#### CITY OF ST. PETERSBURG, FLORIDA

#### STAFF REPORT

Community Planning and Preservation Commission Certificate of Appropriateness Request

Case No.: 22-90200051

Figure 4: Proposed side renderings of the project.

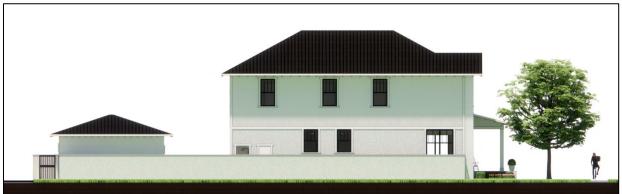
Staff suggests that the following elements of the proposed building be closely considered by the Commission in their review, as features that most closely define its relationship with the historic district:

Figure 5: Depiction of average single-family second story dimensions of 32 feet wide by 30 feet long (orange rectangle) overlayed on submitted plans. The blue line represents the walls of the proposed home's second story.

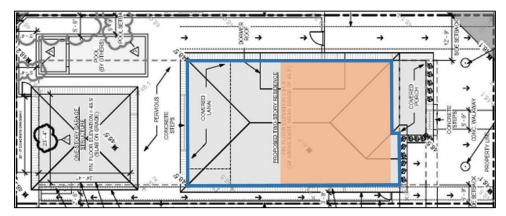
Staff also compared the proposed application to the eight two-story, single-family houses that are contributing to the district (table shown above). Staff found that the average living space of these properties is 1,993 SF, which is significantly less than proposed 3,268 SF. The average FAR of two-story single-family structures in the district is .43, significantly less than the proposed .60 FAR in the application. For contributing single-family buildings, the dimensions of the second story are on average 32 feet wide by 30 feet long. This proposal includes a second story that is 33 feet wide by 55 feet long. This creates a second story massing that is almost twice the length of the average second story of two-story, single-family homes in the district, as shown on the next page in Figure 5.

The proposed two-story house also doesn't incorporate any one-story articulated masses, or bump outs, traditionally found on houses in this district. These small bump outs often serve to create a gesture to a streetside façade or work to break up a larger massing.
